Gas Valve Actuator Wiring Instructions

For ACT00473

Models: ACT00473, MOT08836, SFHF 20 to 75 ton, SFHG 90 to 130 ton

PART-SVN101A-EN

Figure 1. Original MOT08836 Terminal connections, ref. 23093409

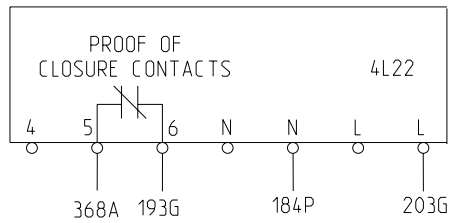
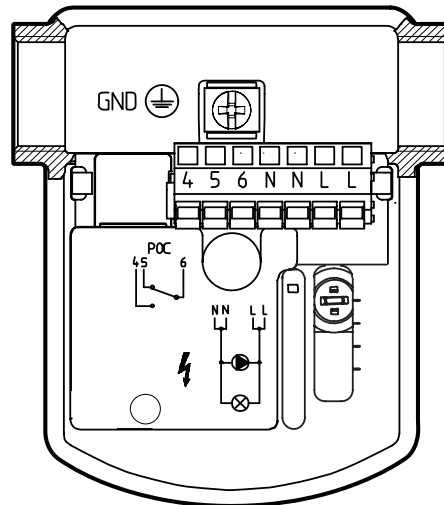
Siemens is replacing their SKP70 actuator (MOT08836) with a single body SKP75 actuator (ACT00473). There are some minor changes to the body of the actuator and to the wire termination and connection points. The physical mounting of the actuator in the unit is interchangeable. This actuator is used on our 20 -130 ton rooftop units.

The old part is MOT08836. The new part is ACT00473.

Please be aware that the terminal designations on the new actuator motor is different from the MOT08836. An example is the POC switch, which has changed from terminals 4-6 to 5-6.

No additional hardware is needed to install the wires to the new actuator. The following four wires connected to the original part should have the old forked terminals cut off. Then strip the wire insulation off about 1/4 inch and place in the clamp style terminal on the new actuator.

Wire 193G Terminal 6
Wire 368A Terminal 5

Wire 184P Terminal N
 Wire 203G Terminal L
